AMENDED BY STAFF 8-2-91
CITY PLANNING COMMISSION
 1231 "I" STREET, SUITE 200, SACRAMENTO, CA 95814

- A. Negative Declaration
- B. Plan Review to construct a 60,800 square foot warehouse building on 8.8± vacant acres in the Light Industrial- Review (M-1-R) zone

LOCATION: Northeast corner of Raley Boulevard and Santa Ana Avenue

EXHIBIT B Phase II Elevations

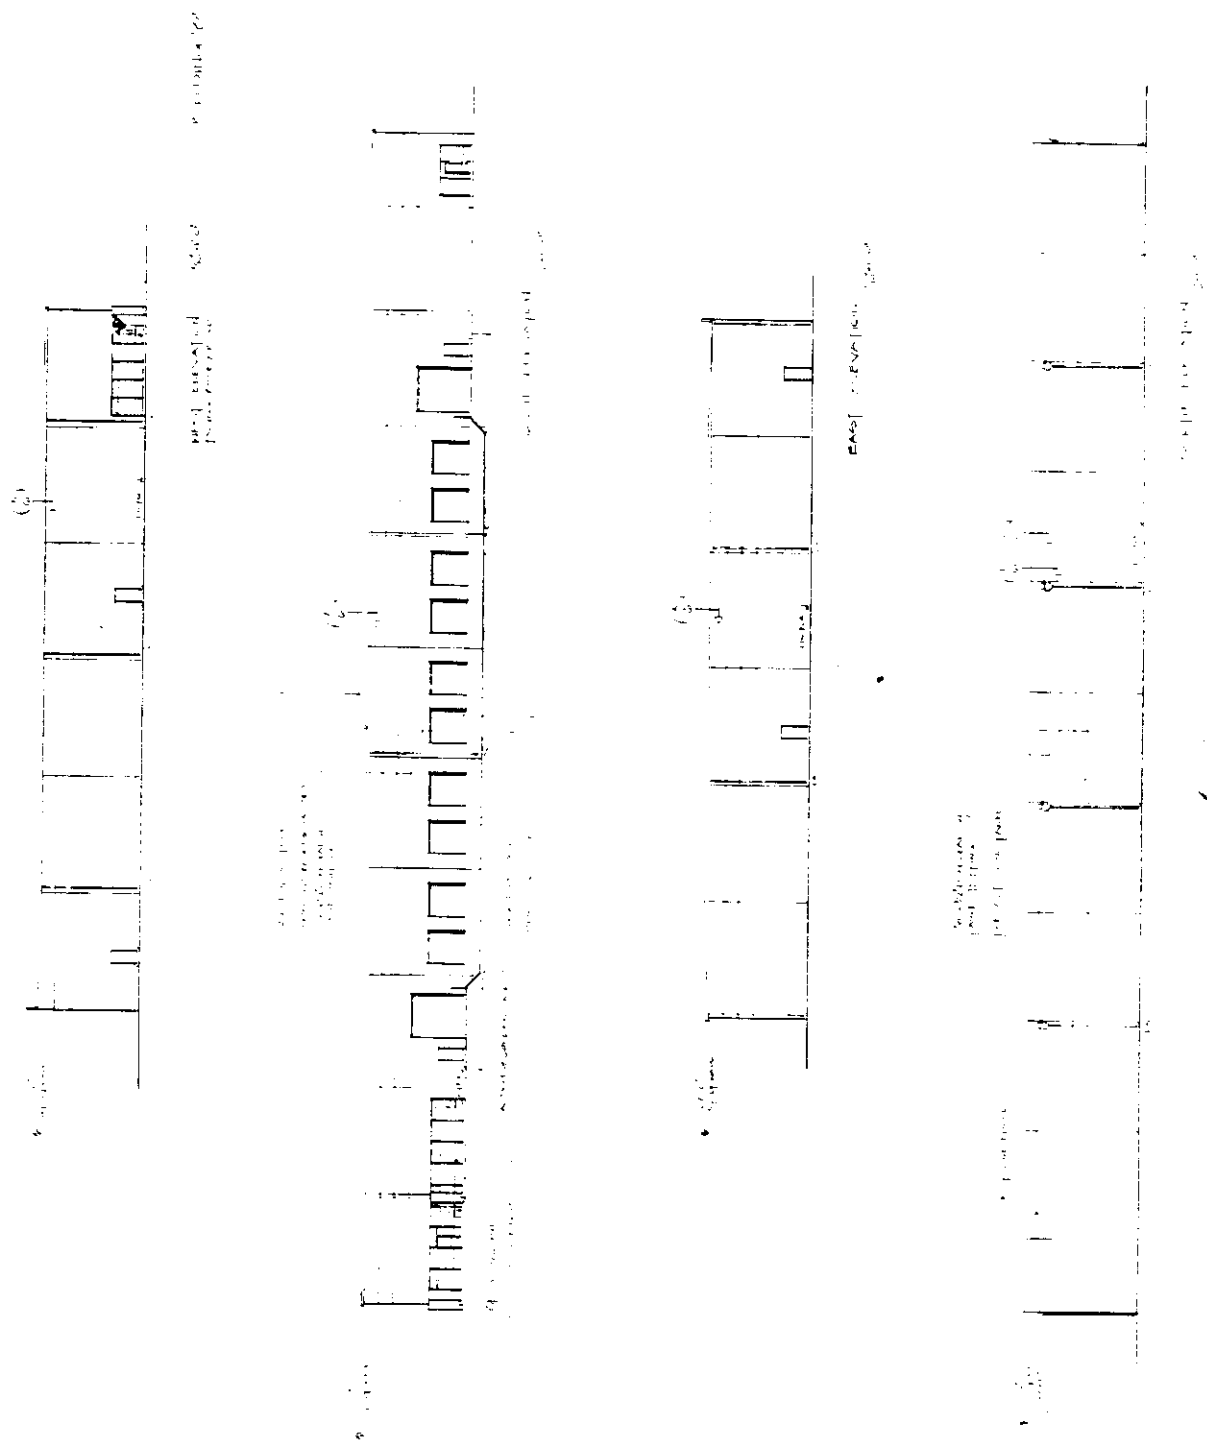
The exterior building materials are proposed to be concrete tilt-up panels with a painted finish. The proposed roof is a built-up parapet roof. The proposed colors are light grey for the walls and doors and orange and dark grey for the three relief stripes. The top and bottom stripe will be orange and the middle stripe will be dark grey. The applicant proposes a 3/4 inch square relief in the concrete panels for each stripe. The applicant indicates striping on all four sides of the building. Design Review staff concurs that each elevation must have the three stripe relief.

4. Each elevation of the building shall have the three stripe relief design enhancement.
5. The office area shall not exceed twenty-five percent of the gross floor area of the buildings on the site. If office area exceeding twenty-five percent of the gross floor area is proposed at a later date, a special permit shall be required. Additional parking spaces shall be required at the ratio of one space for every 400 square feet of office area if additional office floor area is added to the building.
